Subject: AP1000 COL Standard Technical Report Submittal of APP-GW-GLN-122 (TR 122),  
Revision 0

Submittal of Proprietary and Non-Proprietary Technical Document Information,  
APP-GW-GLN-122, Revision 0 and APP-GW-GLN-122-NP, Revision 0, "Offsite  
and Control Room Dose Changes"

TITLE: **Offsite and Control Room Dose Changes**

## Offsite and Control Room Dose Changes

**7. Tier 2, DCD Figure 6.4-2 (Sheet 2 of 2), pg 6.4-22**

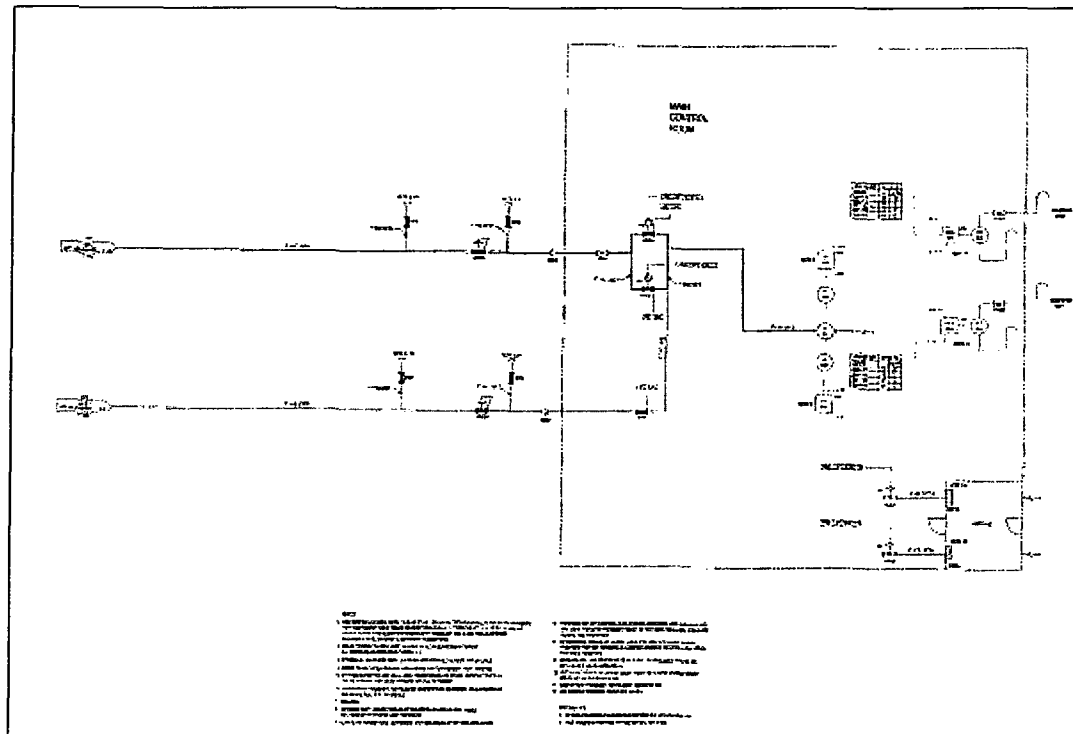
The pressure relief dampers discharge through the MCR vestibule in order to reduce the amount of radioactivity that can be transported into the MCR when operators enter. Two vestibule discharge openings provide a purge flow path from the vestibule to the corridor.
